## DESCRIPTIVE REPORT

*Type of Survey*      Hydrographic  
*Field No.*              RA-20-02-00  
*Registry No.*         H-10950

*State*                      Alaska  
*General Locality*      Northern Clarence Strait  
*Sublocality*             Shrubby Island to Key Reef and vicinity

# Descriptive Report to Accompany Hydrographic Survey H10950

Figure 2. Junction Surveys with H10950

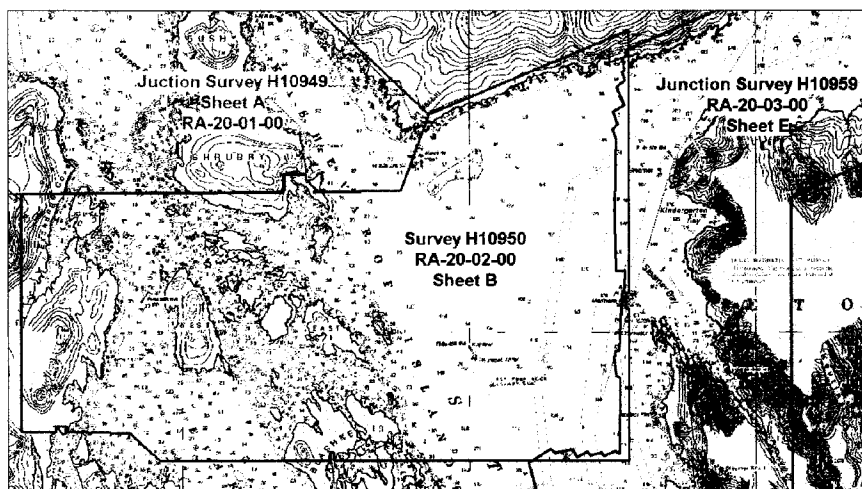
Surveys H10949 and H10959 junction well with this survey, with differences generally less than 1 – 2 fathoms. **CONCUR**

Figure 3. MB Holiday in Clarence Strait.

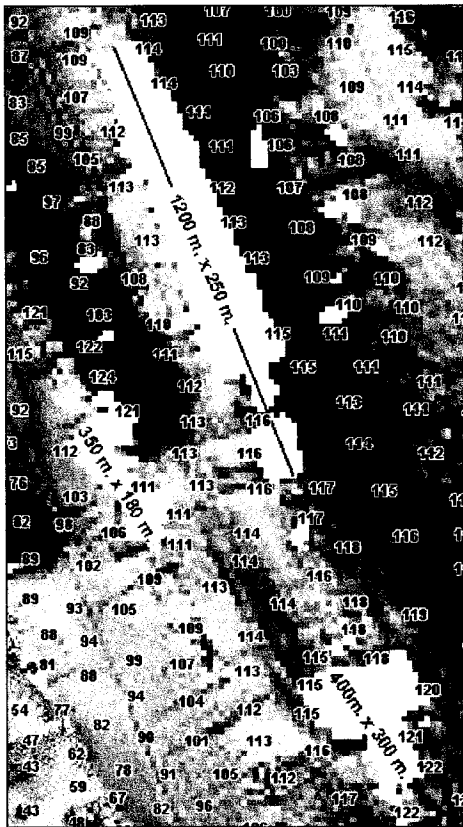
The most notable of these large holidays is in the vicinity of 56°11'32.7"N, 132°52'31.0"W (E631843.6, N6229527.0) in Clarence Strait, east of the Kashevarof Islands. Several large holidays fall within this area, the largest measuring 1200 meters in length by 250 meters wide. Soundings surrounding these holidays are approximately 80 fathoms shoreward and over 100 fathoms seaward. See Figure 3 below.

All of these holidays were closely examined by the Hydrographer and were not deemed significant to navigation. The size of some of these holidays exceeds the required sounding density at survey scale. As previously mentioned in Section B.2, the data were inspected to ensure that no shoaling exists in these large holidays. In both instances all surrounding depths are greater than 100 fathoms. The Hydrographer believes that coverage was still sufficient to remove the green tint indicating wire drag clearance from chart 17382. *Concur*

Figure 4. MB Holiday in Clarence Strait.

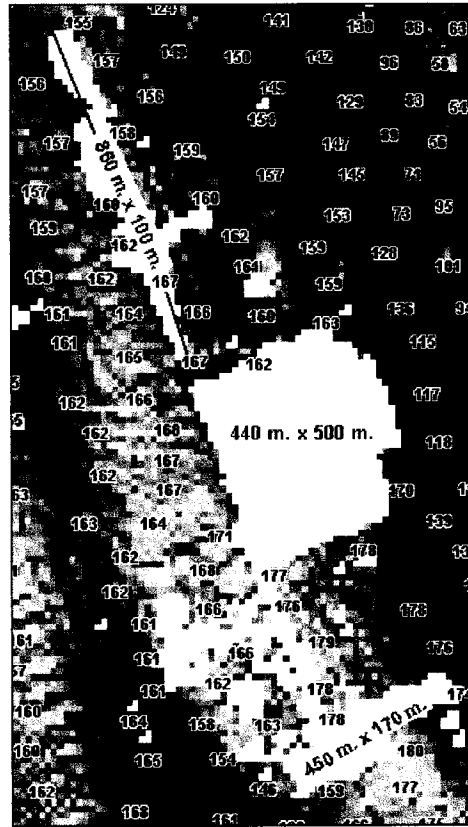
Another notable holiday is in the vicinity of 56°08'48.0"N, 132°50'45.6"W (E633819.1, N6224492.8) also in Clarence Strait just east of the Kashevarof Islands. Several large holidays fall within this area, the largest measuring 440 meters wide by 500 meters in length. Soundings surrounding these holidays are approximately 160 fathoms in depth. See Figure 4 below.
